ROSSITER DAM

NDI I.D. PA-1080

PHASE I INSPECTION REPORT
NATIONAL DAM INSPECTION PROGRAM

D'APPOLONIA CONSULTING ENGINEERS
10 DUFF ROAD
PITTSBURGH, PA. 15235
AUGUST 1981

PLATE 3

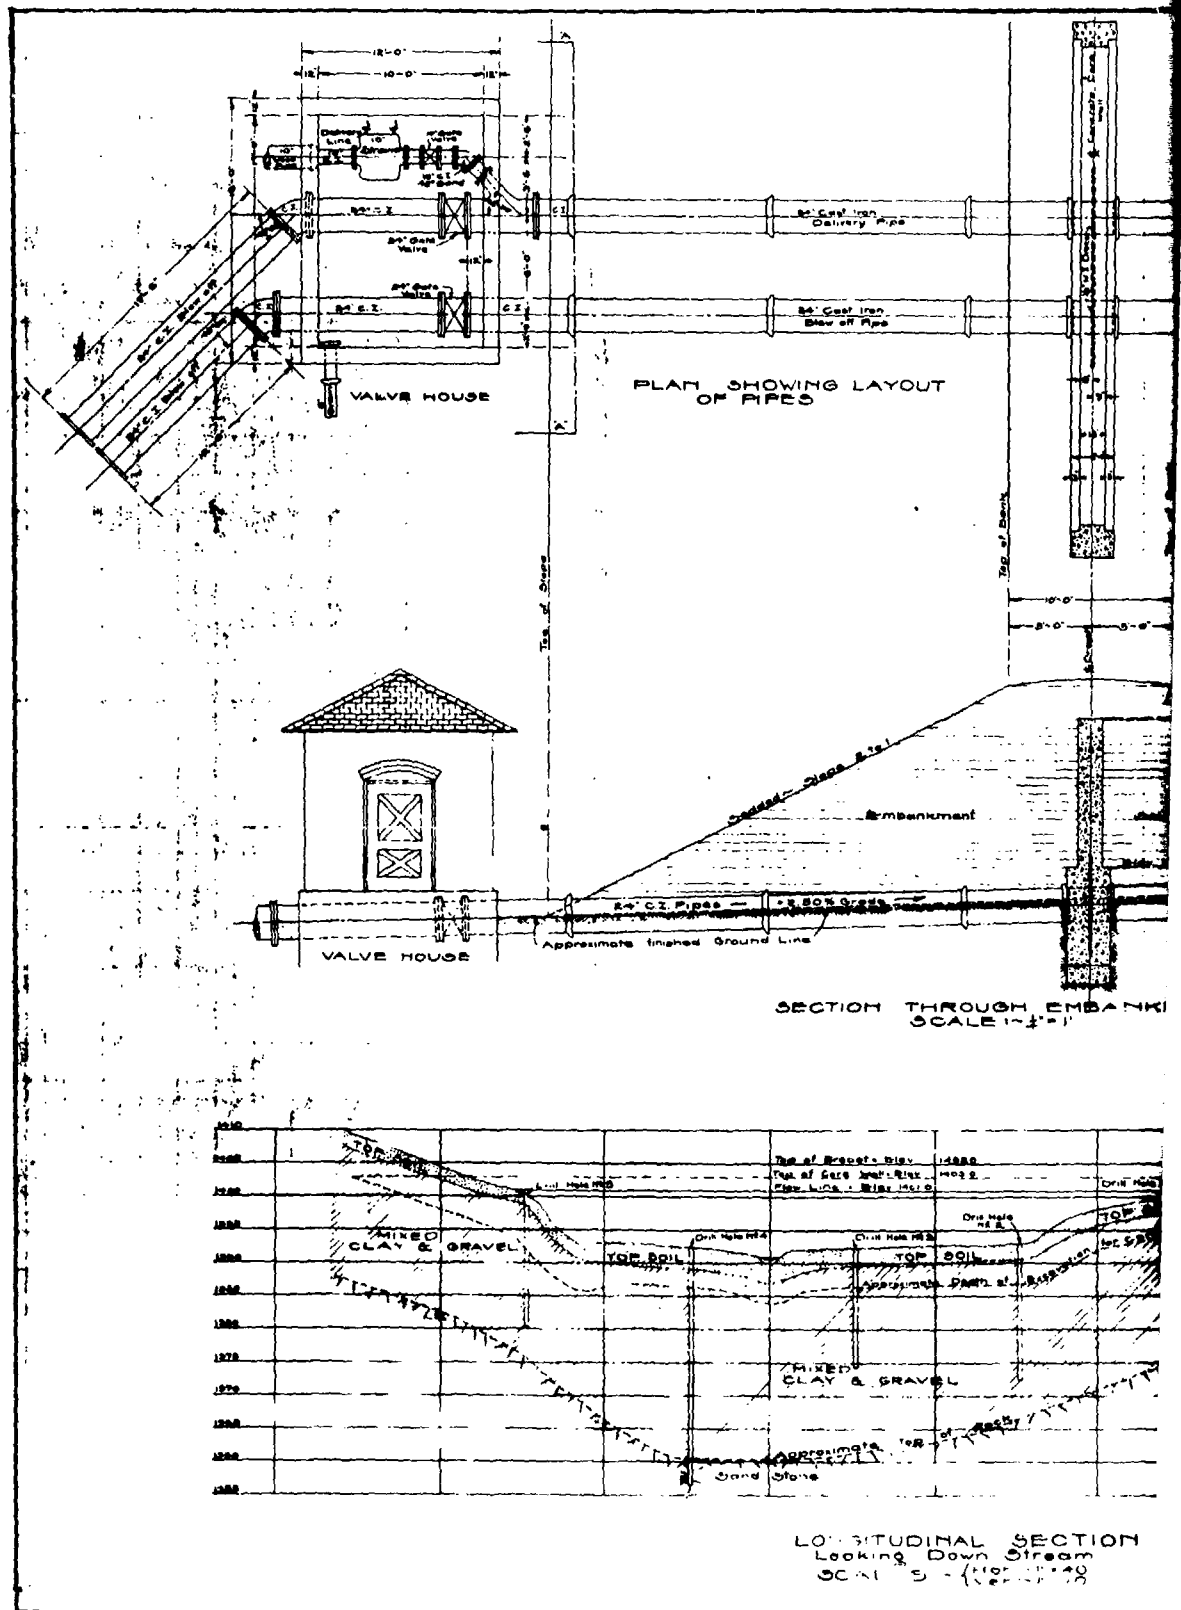
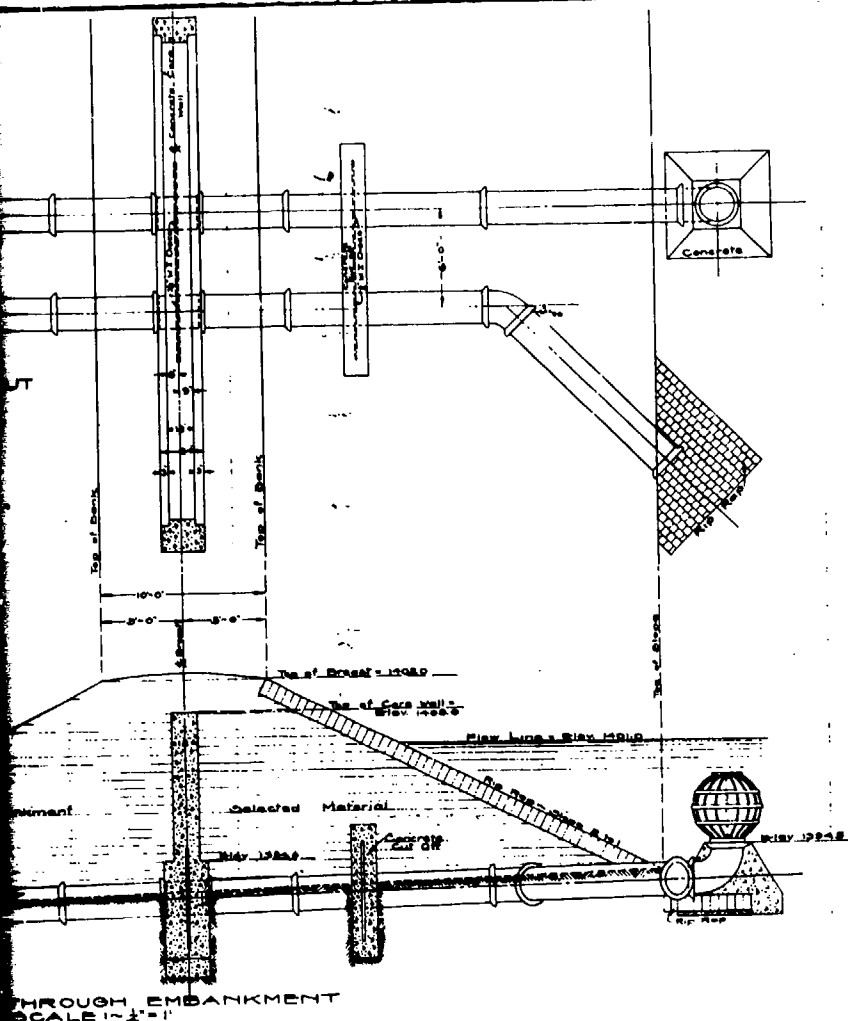
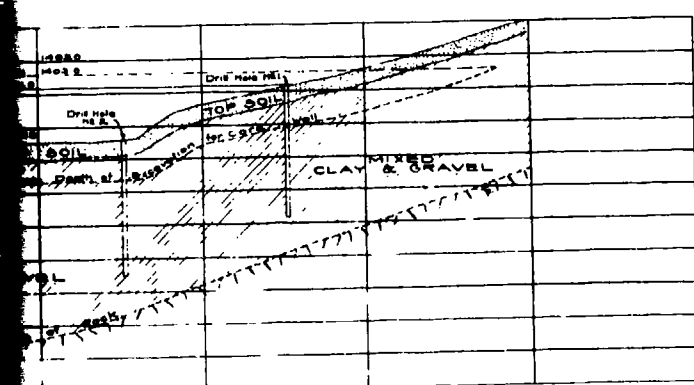
(1) Embankment. Plate 2 illustrates the plan of the embankment and the reservoir. As shown on Plate 3, the dam consists of a homogeneous earth embankment with a central concrete core wall for the full length of the embankment. Plate 3 also shows the valley profile indicating that the concrete core wall was extended to a depth of approximately five to eight feet below the top of ground. The dam was designed to have 2 horizontal to 1 vertical slopes on both the upstream and downstream faces. The design provided riprap protection on the upstream face extending from the upstream toe of the embankment to the dam crest.

(2) Embankment. In view of the age of the dam (completed in 1919), it is clear that the design approach and construction technique are not likely to have been in conformance with currently accepted engineering practice. Design documents lack such considerations as embankment slope stability and seepage analyses. However, the design incorporated such basic components as a concrete cutoff and core wall and downstream slope protection.

FLATE 4
 ROSSITER DAM
 GENERAL PLAN
 FIELD INSPECTION NOTES
 FIELD INSPECTION DATE: JULY 16, 1981
D'APPOLONIA

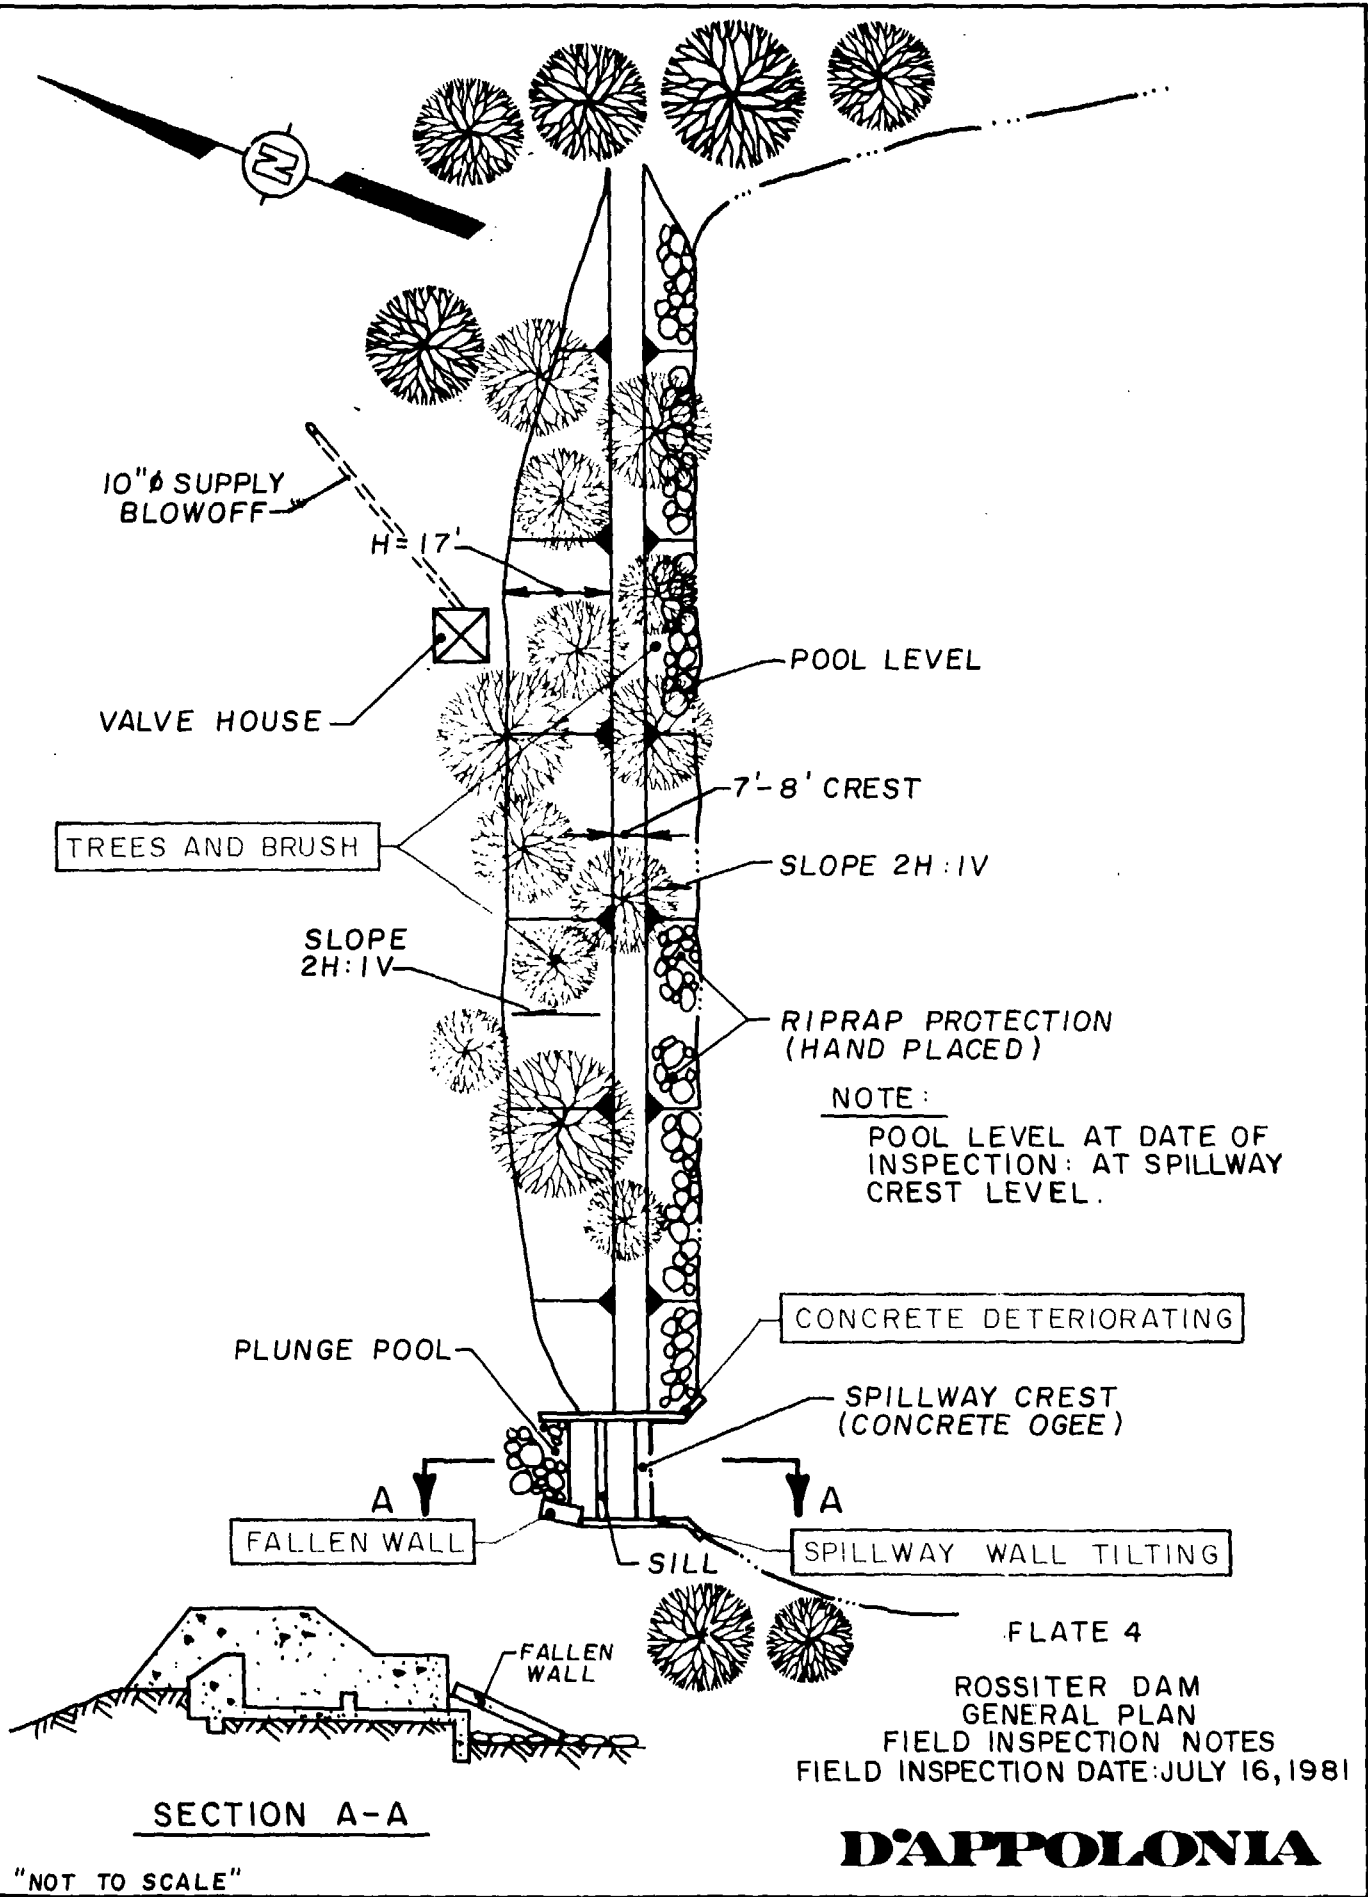
The specific observations are illustrated in Plate 4.

The crest, downstream slope, and the area in the vicinity of the downstream toe were found to be covered with dense trees and brush, precluding a complete inspection of the dam. To the extent that it can be determined, the embankment is considered to be in fair condition structurally. No significant signs of distress or seepage were noted.

c. Appurtenant Structures. The appurtenant structures were examined for deterioration or other signs of distress and for obstructions that might limit flow capacity. In general, the spillway structures were found to be in poor condition. A segment of the spillway sidewall has collapsed and the remaining segments are only marginally stable. The entire structure has significantly deteriorated.
